Meeting: 12/15/2021
Applicant: Meghann Gregory
Owner: George Daws

Location: 2621 Barton St. **Parcel ID** 81 D D 033
Zoning: RN-2 (Single-Family Residential Neighborhood)
District: Edgewood Park Infill Housing Overlay District

Level II Additions Visible from the Primary Street

12-C-21-IH

1 Architectural Site Plan
 A101 1" = 20'0"

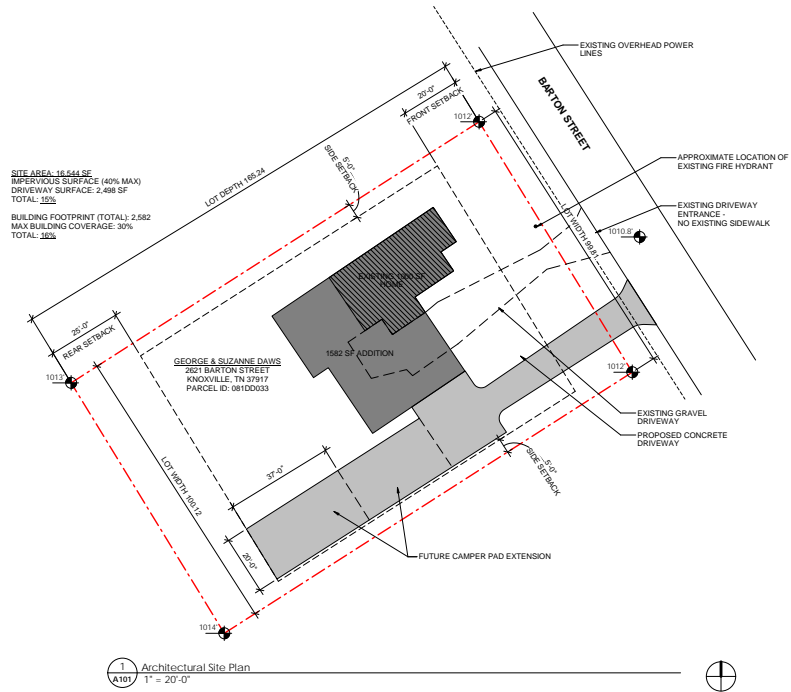
4. Removing the gravel driveway and replacing with a new concrete driveway meets the design guidelines for streets without alleys; parking will be recessed behind the house's façade and limited to one lane
-

2 Left Elevation
 A301 1/8" = 1'-0"

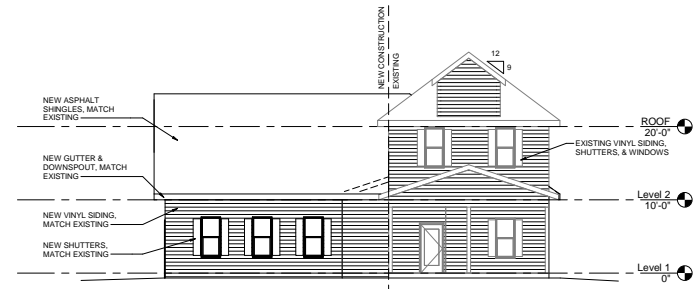
3. The addition incorporates materials to match the existing house; while Infill Housing reviews regularly discourage the use of Dutch lap vinyl siding, the proposed siding matches the primary house. The roof materials, 8/12 roof pitch, and one-over-one windows are compatible with the primary house. Window placement on the façade and left side elevation meet the design guidelines.
